## SERVICE BULLETIN SUMMARY

TITLE: AIR CONDITIONING - PACK TEMPERATURE CONTROL - INSTALL A MODIFIED PACK

MODIFICATION No.: 28488K6156

6 DATE: Jul 07/99 SERVICE BULLETIN No.: A320-21-1118

Figure 1 Sheet 1
Removal/Installation of Pack Controllers 7HH and 27HH

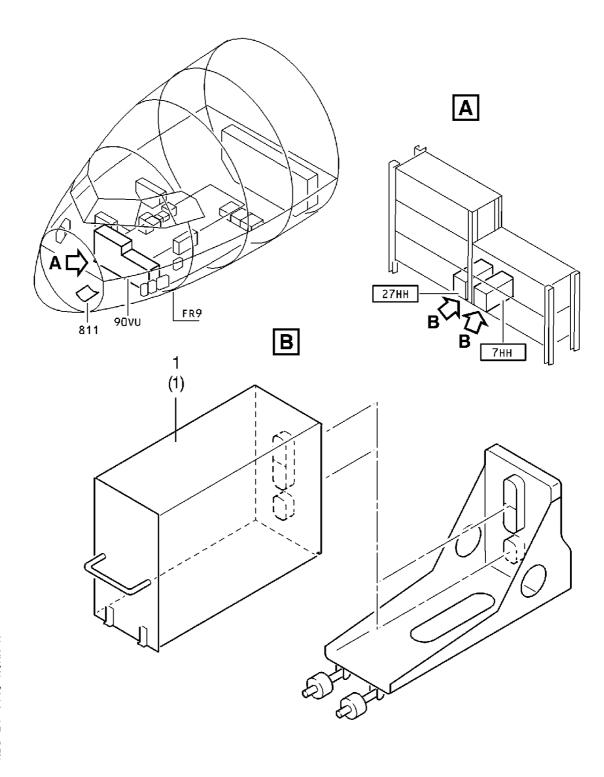
Refer to Figure 1

- (a) Remove the pack controllers 7HH and 27HH, (Refer to AMM 21-61-34 Page block 401).
  - 2 controllers
- 75900000-01

- (b) Modify the pack controllers 7HH and 27HH, PN 759D0000-01 (Refer to LIEBHERR AEROSPACE LINDENBERG Service Bulletin No.759D-21-01).
- (c) Install the modified pack controllers 7HH and 27HH, (Refer to AMM 21-61-34 Page block 401).
  - 2 controllers
- 759D0000-02
